Proposal for Supplement 2 to the 07 series of amendments to Regulation No. 14
(Safety-belt anchorages)

Submitted by the experts from Germany and Belgium

Note: The text reproduced below was prepared by the experts from Germany and Belgium in order to introduce prescriptions for side-facing seats in vehicles of category M₃ (Class II, III and B).

Insert a new Figure 1b, to read:

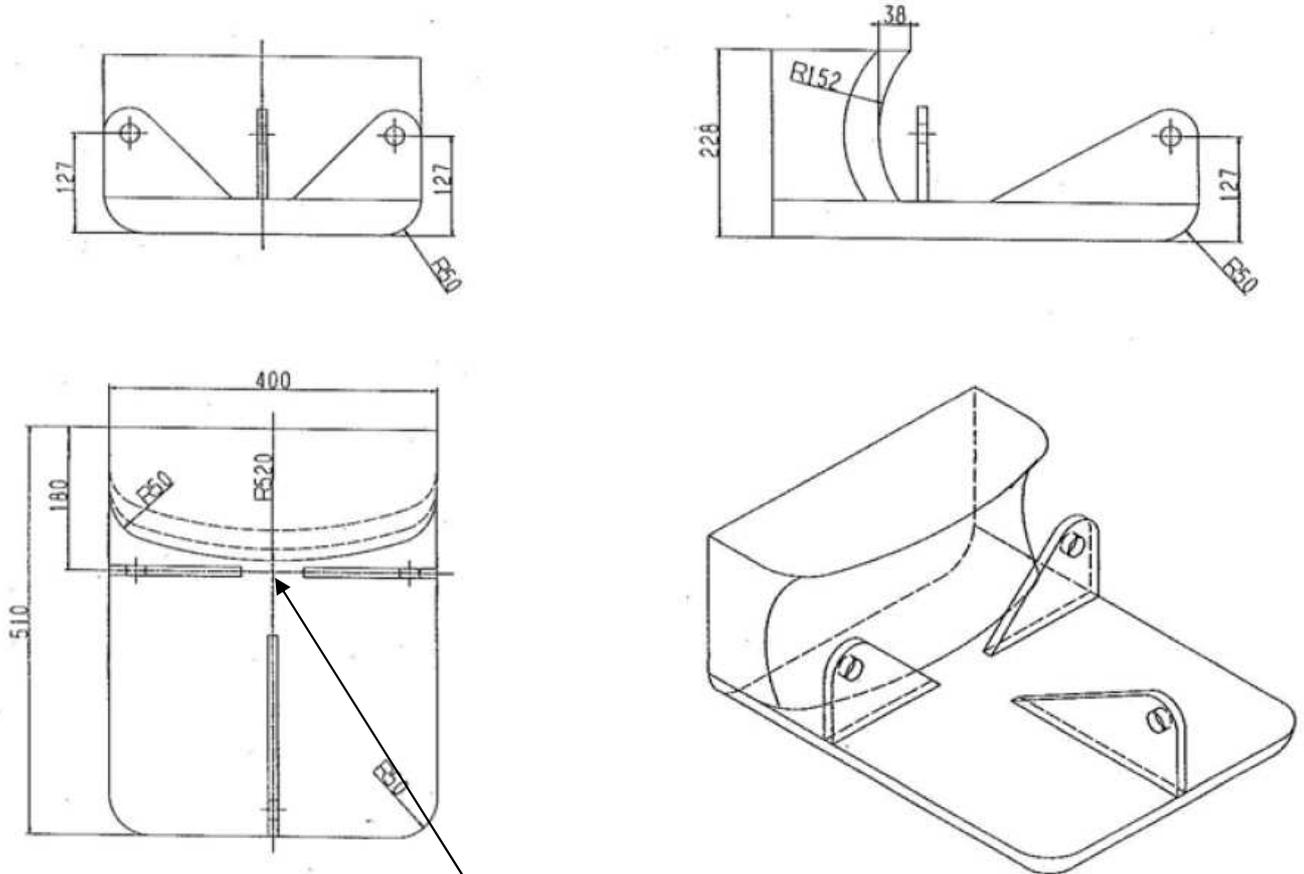
6.4.7.3. Traction devices adapted for the test of side-facing seats are shown in Annex 5 Figure 1c.

6.4.8 Test of the basic structure of side-facing seats

6.4.8.1. The basic structure of a side facing seat or a group of side facing seats shall be tested as prescribed in paragraph 6.4.3. The test load shall correspond to the test load prescribed for M₃ vehicles.

6.4.8.2. The test load shall be directed forward in relation to the vehicle, corresponding to the procedure prescribed in paragraph 6.3. In the case that side facing seats are grouped together the basic structure shall be tested simultaneously for each seating position in the group.

6.4.8.3. The point of application of the forces prescribed in paragraph 6.4.3. and 6.4.4. shall be as close as possible to the H-Point and on the line defined by a horizontal plane and a vertical transverse plane through the relevant H-Point of each seating position."
